ON-SITE WASTEWATER
DISPOSAL SYSTEM

NEWPORT STATE AIRPORT

REDLING ASBUILTS BY
CASSELLA CONSTRUCTION, INC.
3/12/18 (DWG FILE ALSO COMPLETED
WITH SURVEYED ASBUILT LOC. OF PIPES)

SCHEDULE B - WASTEWATER SYSTEM - BID SET

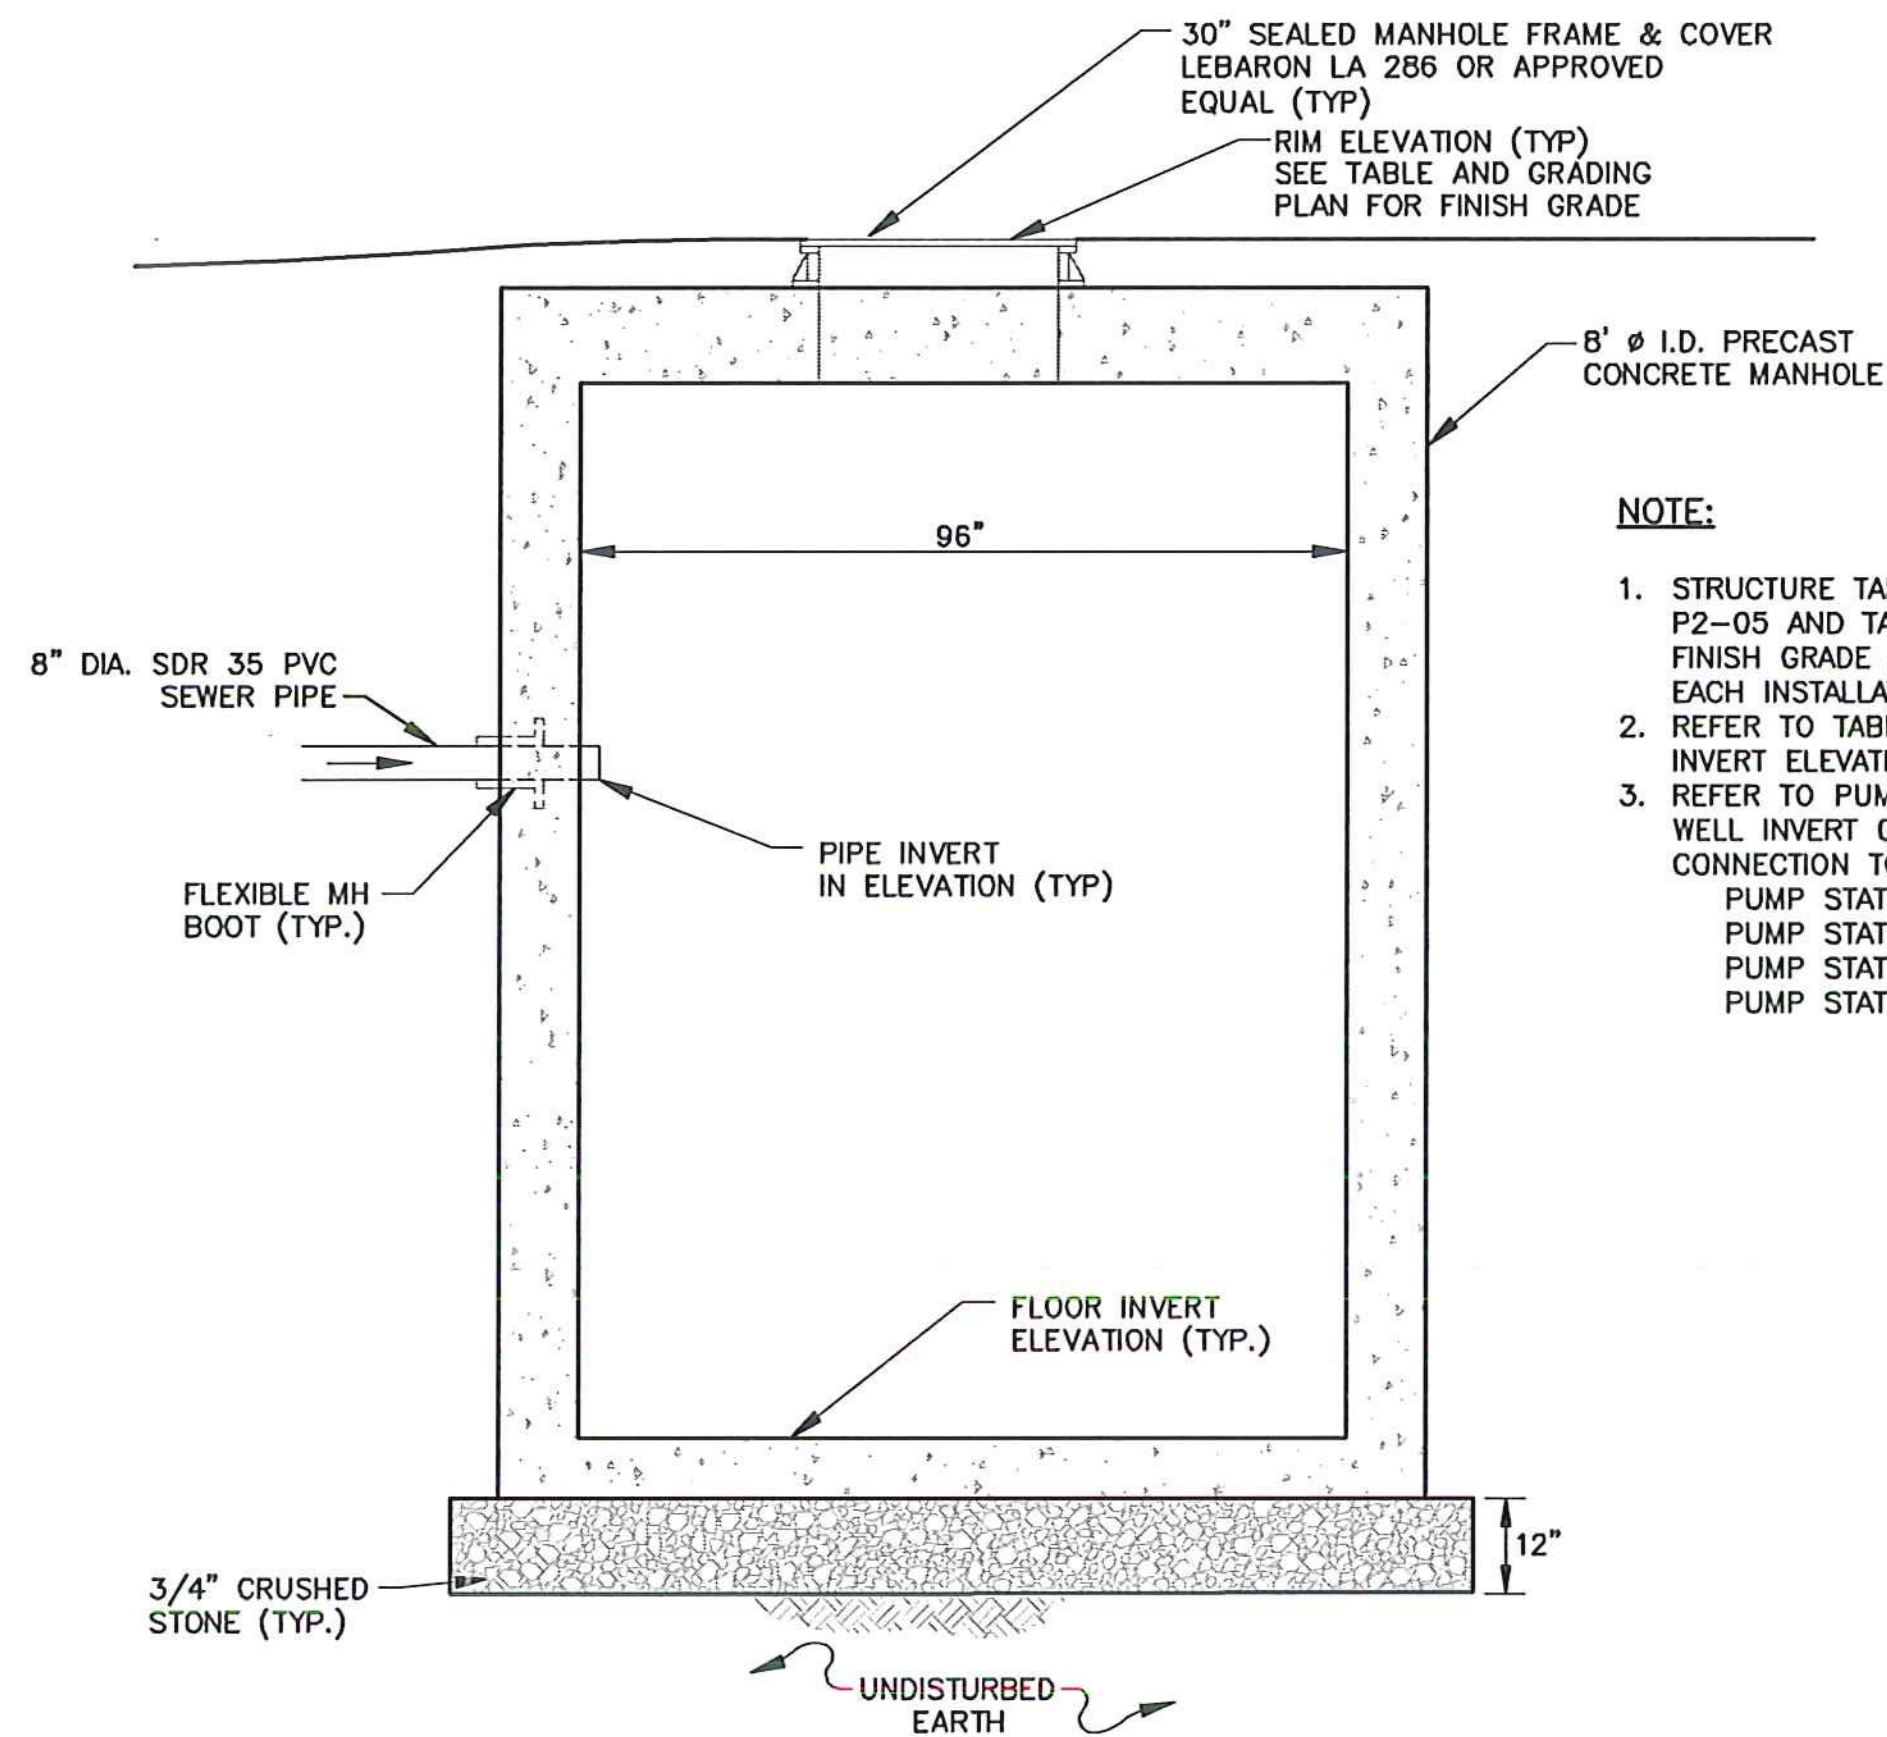
HDPG SDR 11 (See RFI #1)

SCALE: 1" = 20'	DESIGN: TCB	E-01 36 OF 36
DRAWN: MTF	PROJECT: 17958.01	
CHECKED: BLS	DATE: JUNE, 2014

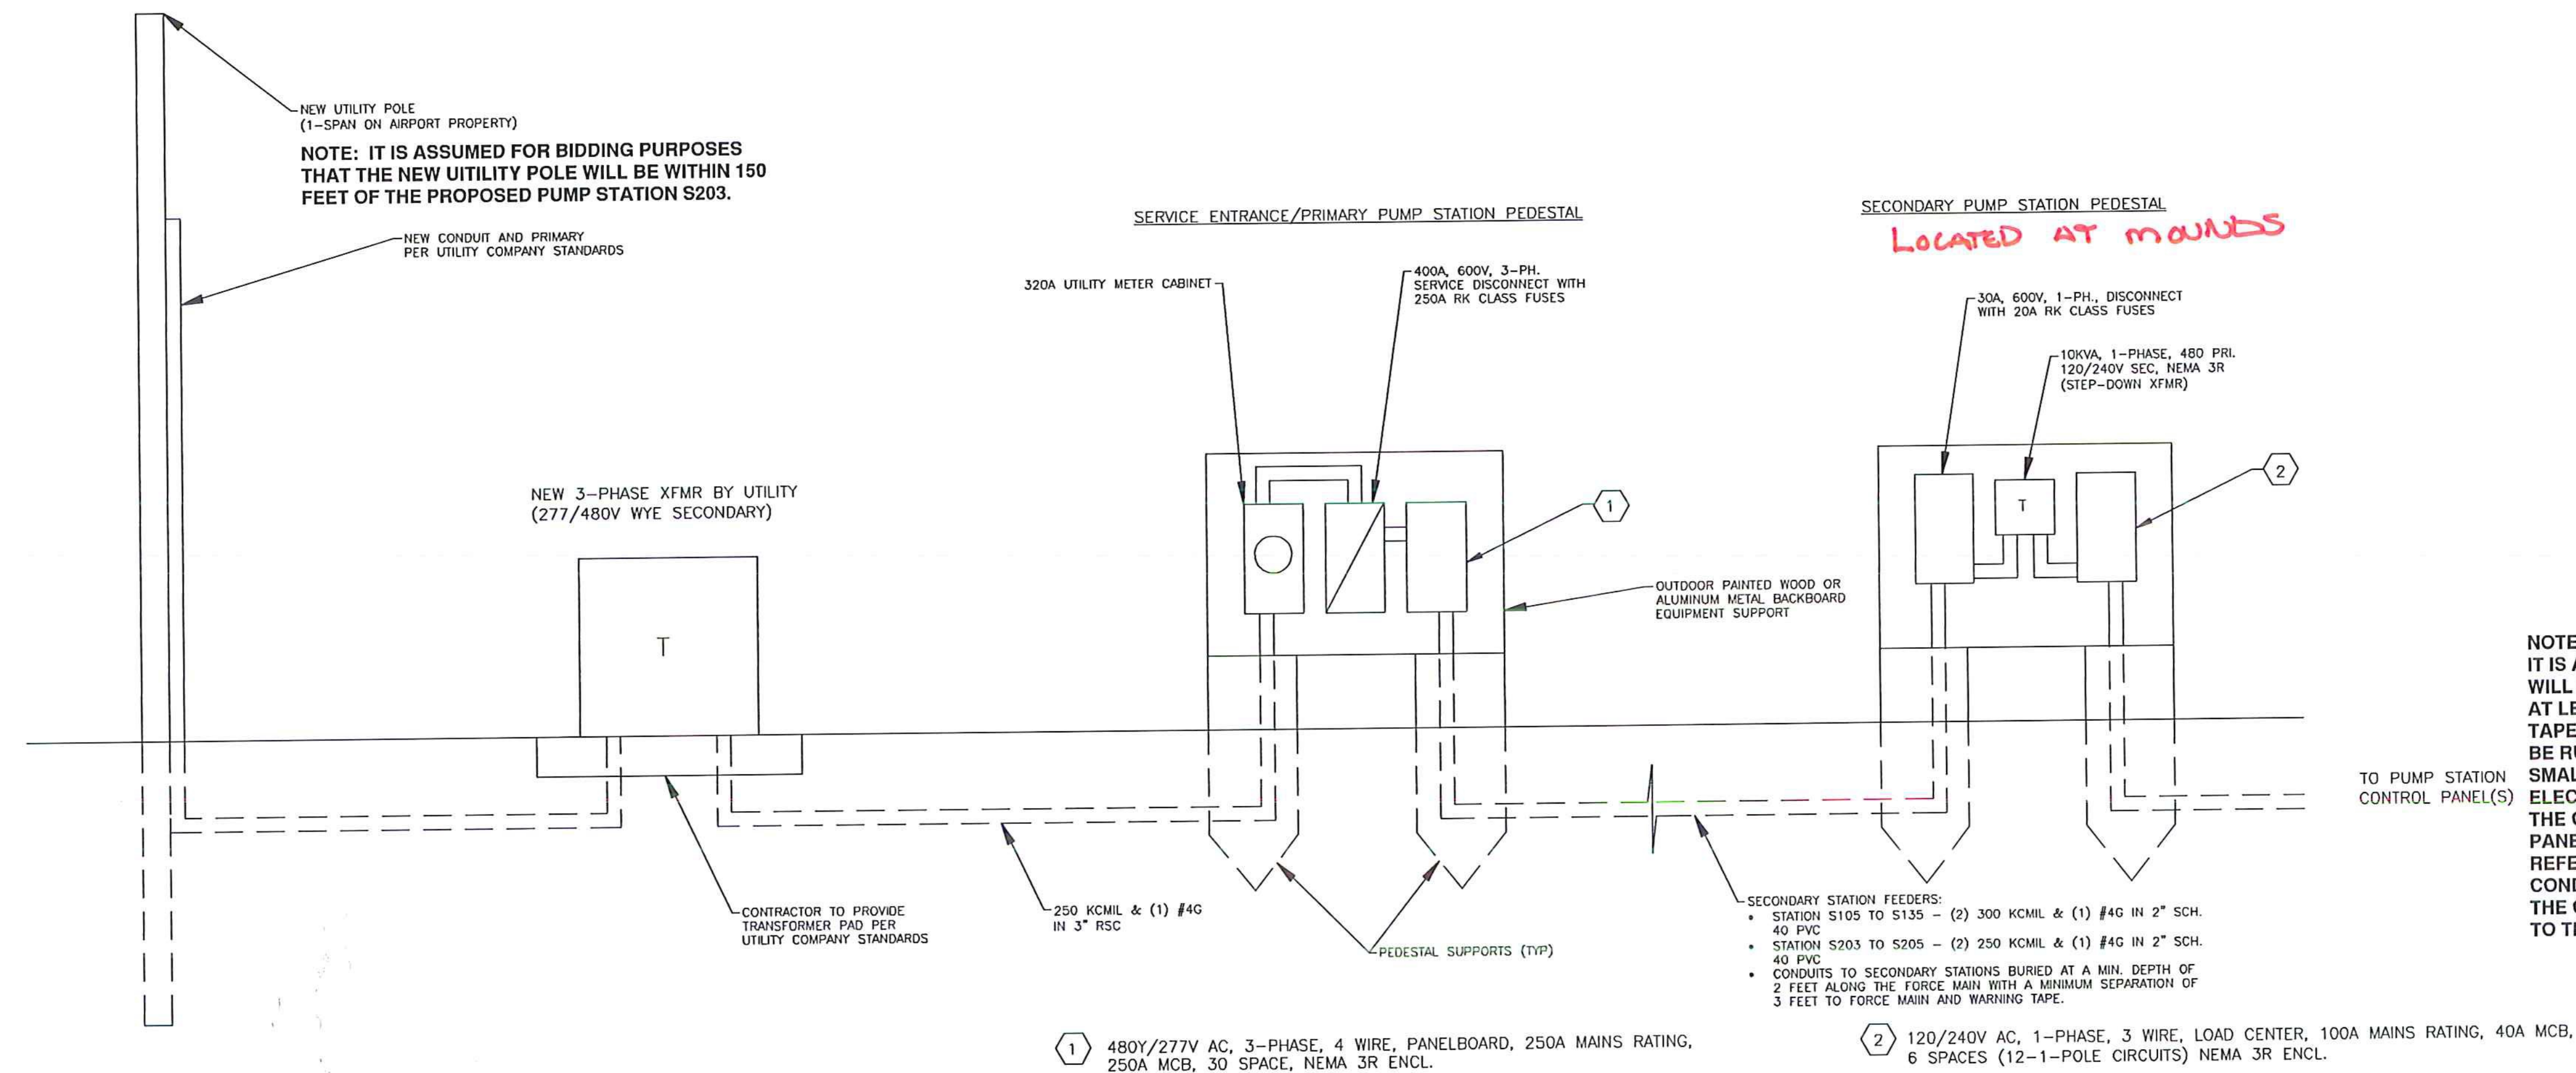
*SEE RFI # 9 FOR CLARIFICATION ON SERVICE CONNECTION (OPT. 2 WAS CHOSEN)*
